CMB Meeting Minutes #145

SUBJECT: Configuration Management Board Meeting # 145 – Rev. No. 0

Contract No. 1252 Tunnels Date 10/18/2013
 PCC No. 1252-14
 PCC Title Modifications to AWSS Facilities at 4th and Bryant Streets

CONTRACT NO.	
1252	
FILE NO.	
91,647	
DRAWING NO.	REVISION
AW-501.5	0
SHEET NO.

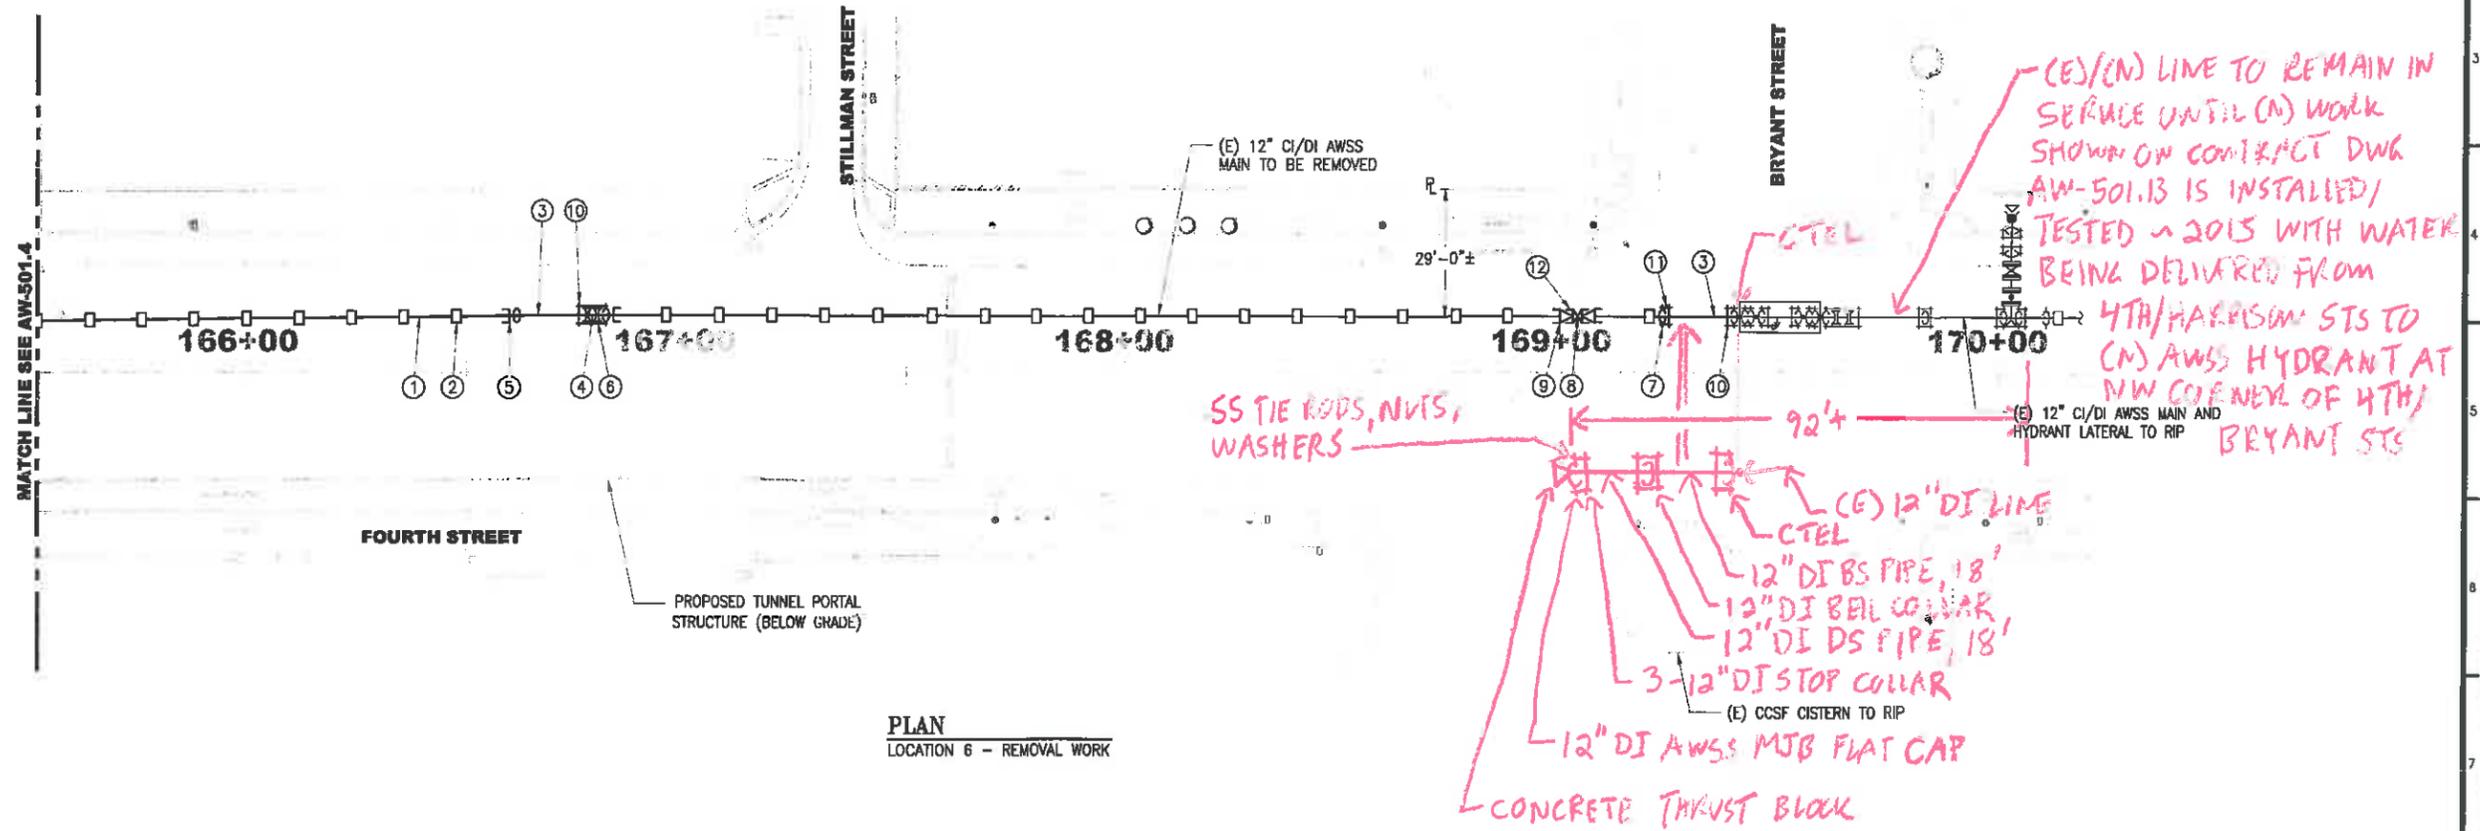
- Delete approximately 75' of 12" flanged pipe, two (2) flanged 45-degree elbows and thrust blocks
- Delete approximately 40' of 24" encasement sleeving

- Delete original hydrant lateral layout on I-80 off ramp, including gate valve, vertical offset piping, 90-degree elbow, thrust blocks, AWSS hydrant, bollards (4) and concrete pad

Recommended Action: Delete the proposed 12" diagonal flanged AWSS main and encasement sleeving crossing the 4th and Bryant Streets intersection as shown on the attached edited drawing AW-501.13.

<p>Delete the proposed 8" hydrant lateral to be installed on the I-80 off-ramp as shown on the attached edited drawing AW-501.13.</p> <p>F/I proposed 12" pipe extension and flat cap to the existing 12" CI line to meet AWSS tieback requirements as shown on the attached edited drawing AW-501.5. F/I hydrant lateral to the west side of 4th Street as shown on the attached edited drawing AW-501.5.</p> <p>Detailed design drawings of the AWSS hydrant lateral to be installed on the west side of Fourth Street shall be provided to the Contractor prior to the installation of the 1252 work to install the 12-inch AWSS line on the west side of Fourth Street. The approximate location and layout of the hydrant lateral is shown on the attached edited drawing AW-501.13. The hydrant lateral shall require a vertical offset, air valve and two (2) 90-degree elbows. The gate valve shall be located between the tee and the hydrant instead of off the tee due to existing and new utility conflicts at this location.</p>

CONTRACT NO.	1252
FILE NO.	91,655
DRAWING NO.	AW-501.13
SHEET NO.	0

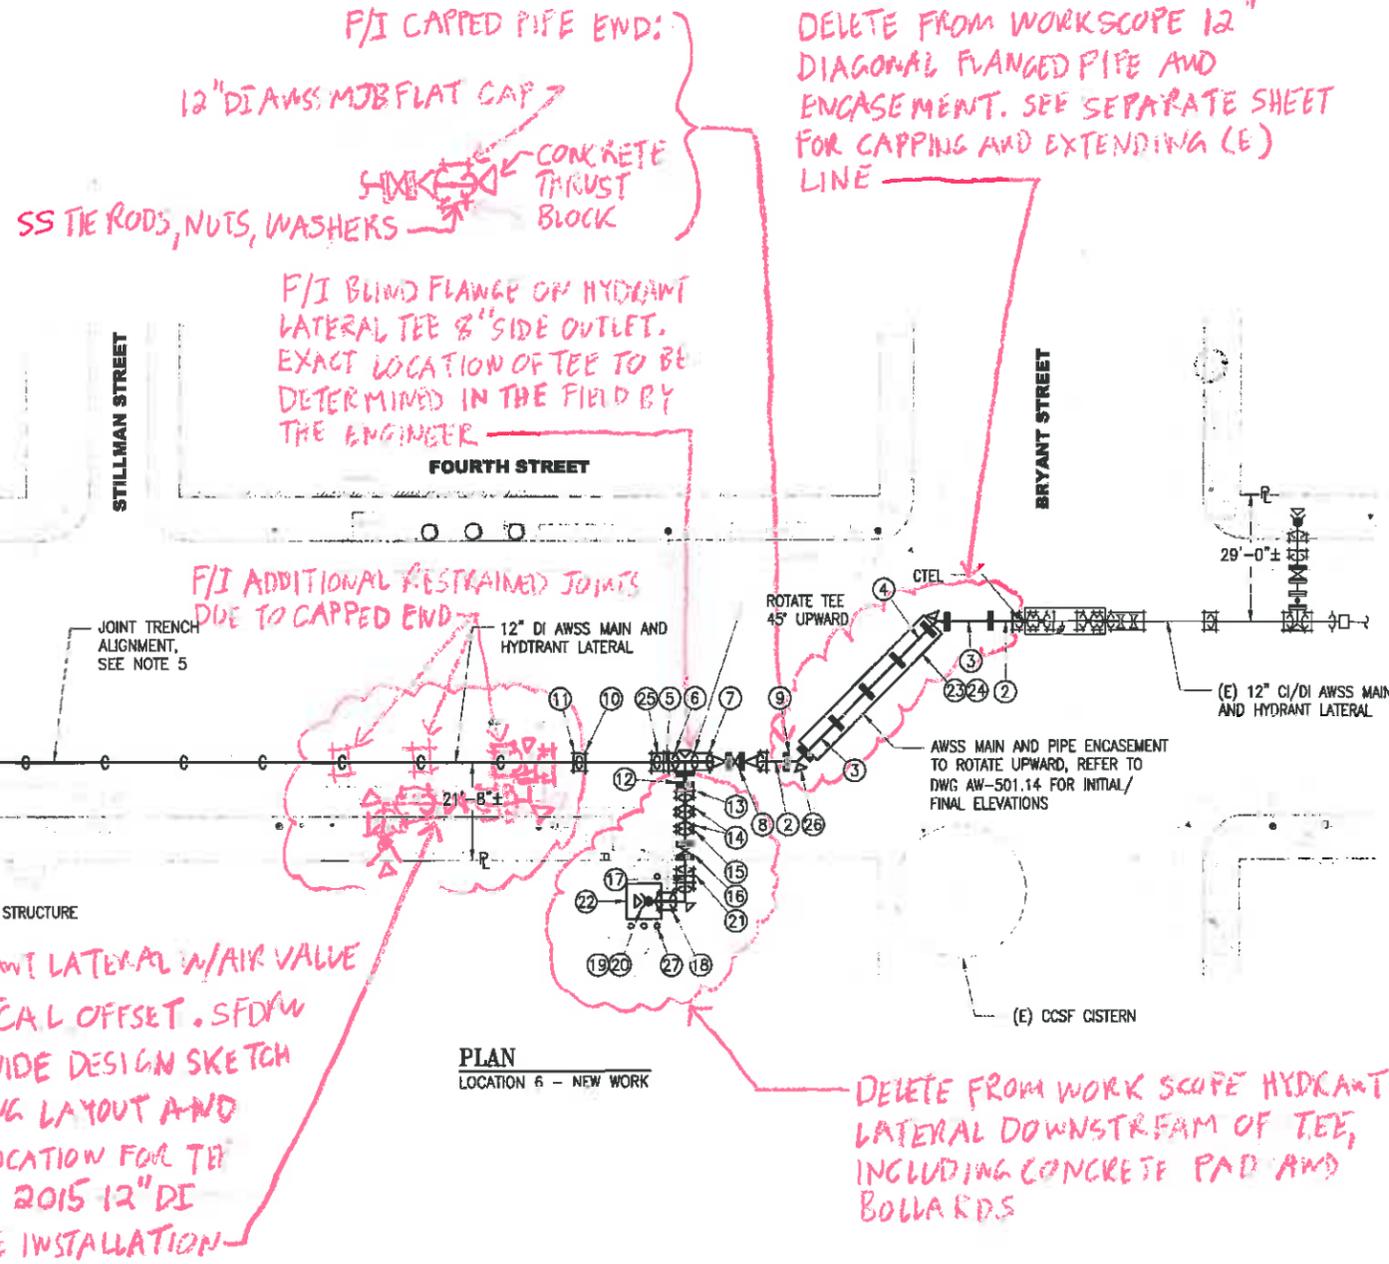
Relocate AWSS hydrant from off-ramp to 4th Street. Install 12" AWSS restrained pipe and hydrant lateral to facilitate future connection. Delete 12" AWSS diagonal sleeved pipe crossing and hydrant lateral.
